## **Appendix 12**

### **Responses to Comment**

Route 9  
Between Tsing Yi and Cheung Sha Wan  
Detailed Feasibility Study

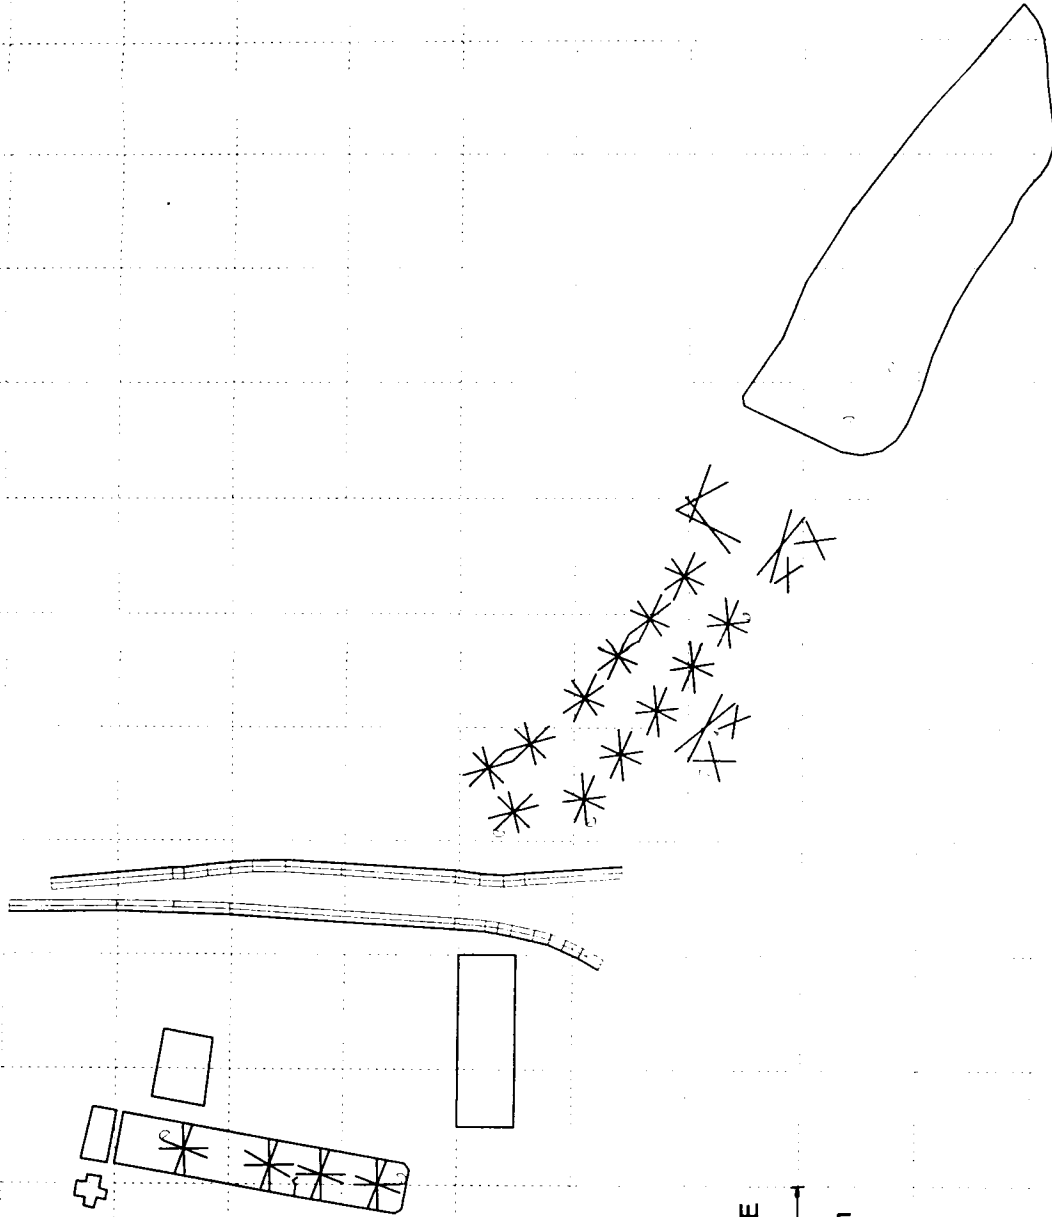
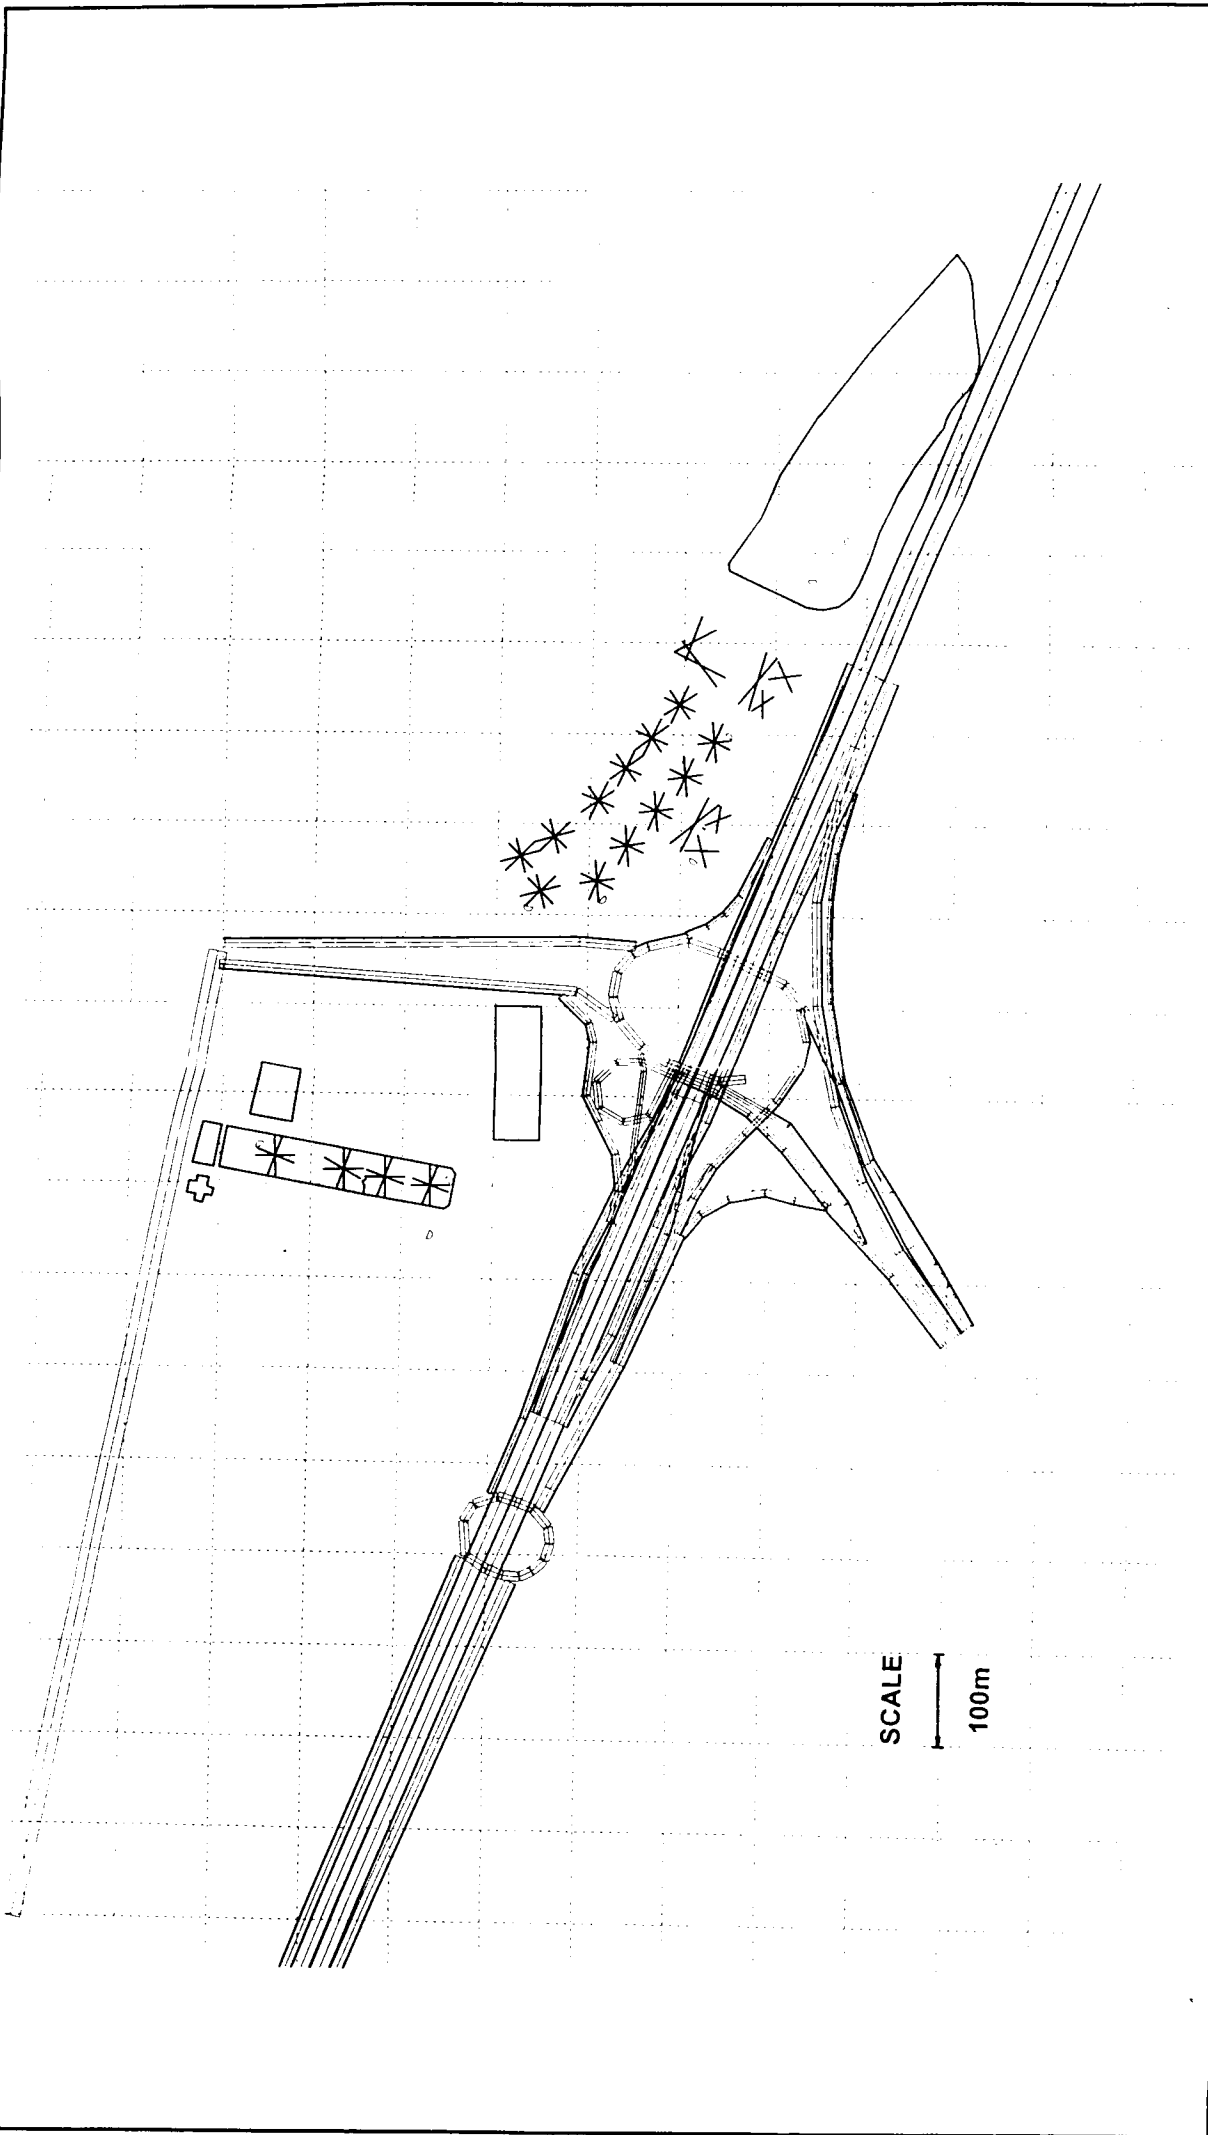
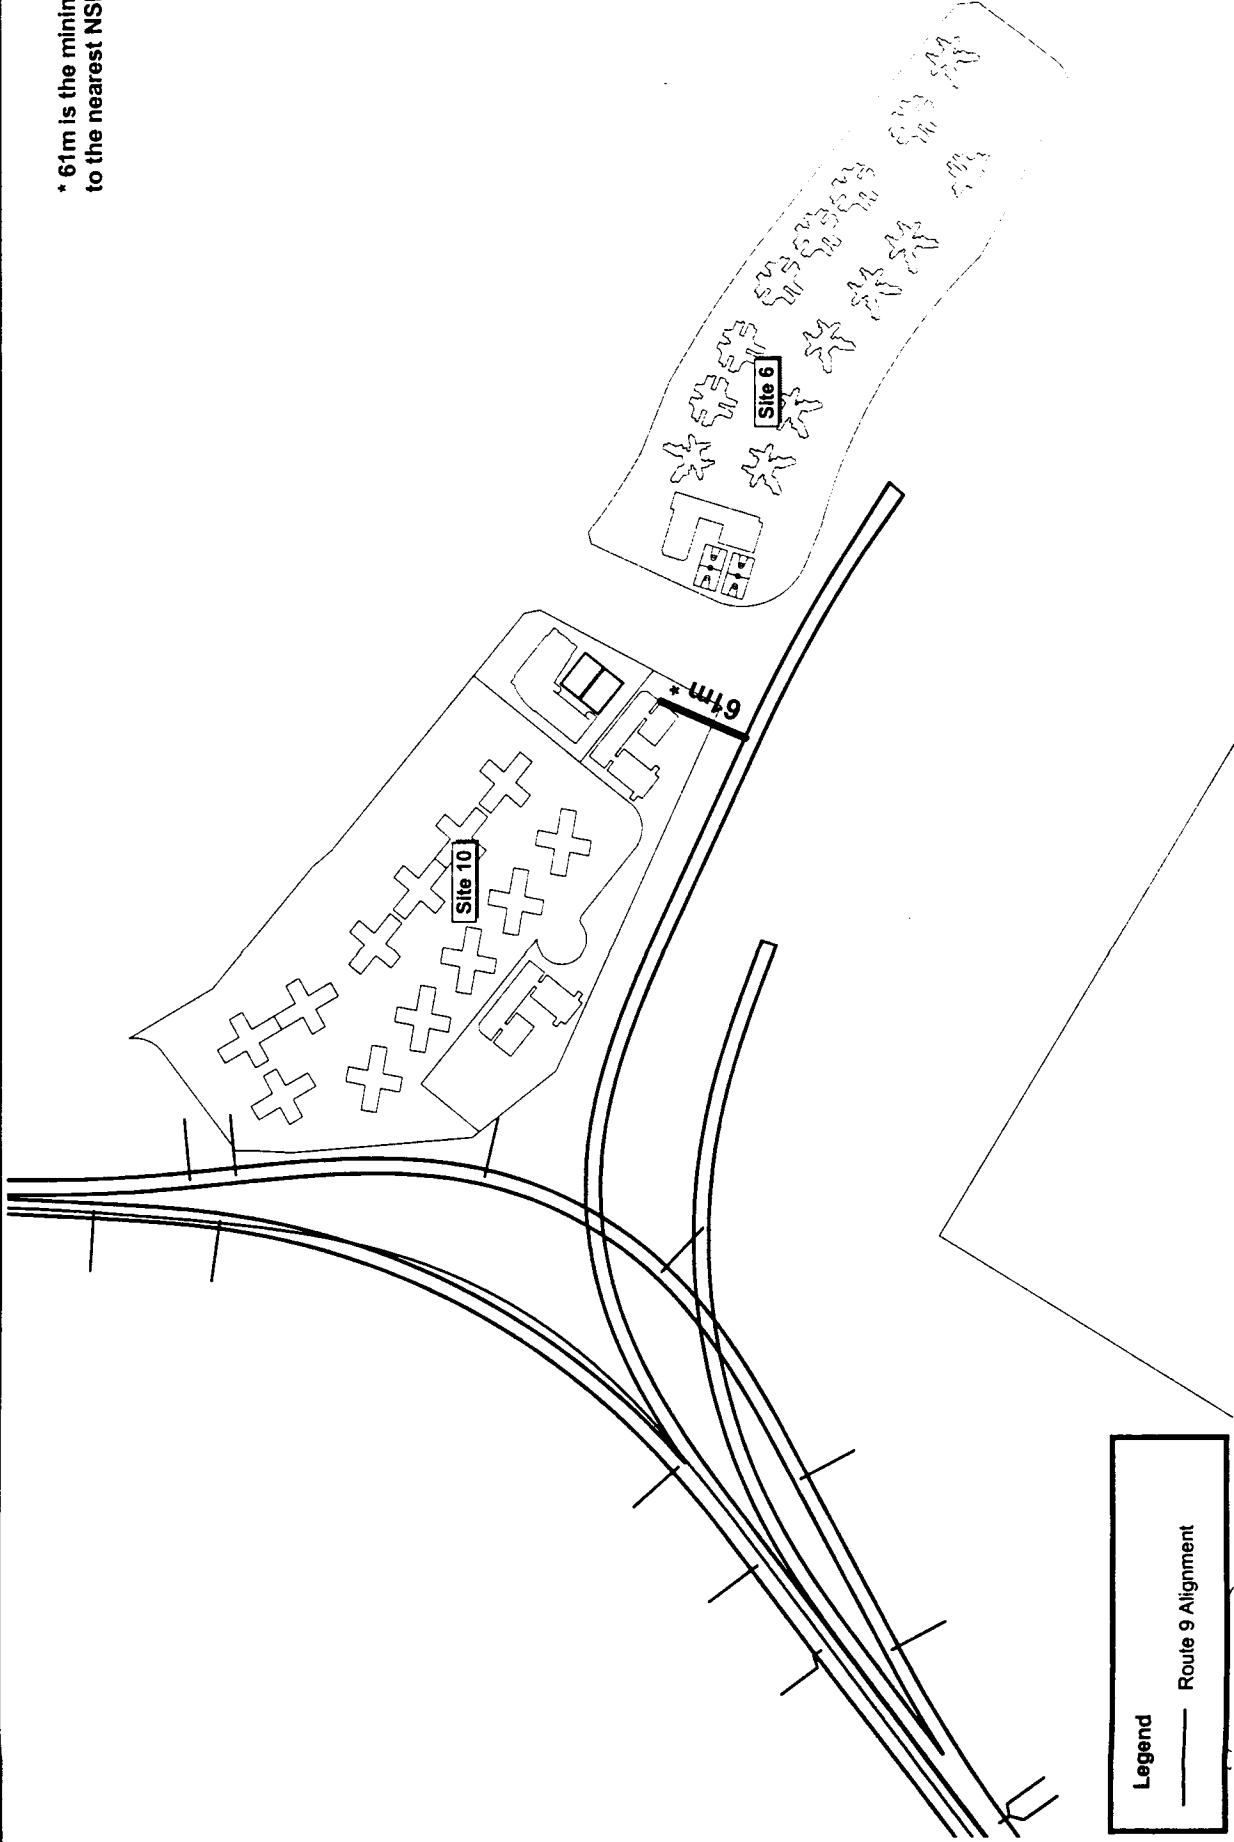
Appendix 1, Figures A1 to A4	Provide the scales of the figures.	Figures amended with scales.
Figure 1.5	Indicate representative NSRs such as MF1 and KMB1 and the adopted layout for Sites 10 and 6.	Figure 1.5 amended.
Figure 2.1 & 2.2	(i) Correct the 2 scales shown on each figure. (ii) Indicate on a 1:2000 plan clearly the recommended noise barriers, with chainage, near the Lai Wan Interchange.	Figure 2.1 & 2.2 amended.
Figure 2.3	Indicate the distance from the barrier and the nearest lane and provide a typical detail of the recommended 3m noise barriers.	Figure 2.3 amended.
Figure 2.4	Correct the location and the noise levels of the NSRs as per Tables 2.7 and 2.10.	Figure 2.4 amended.
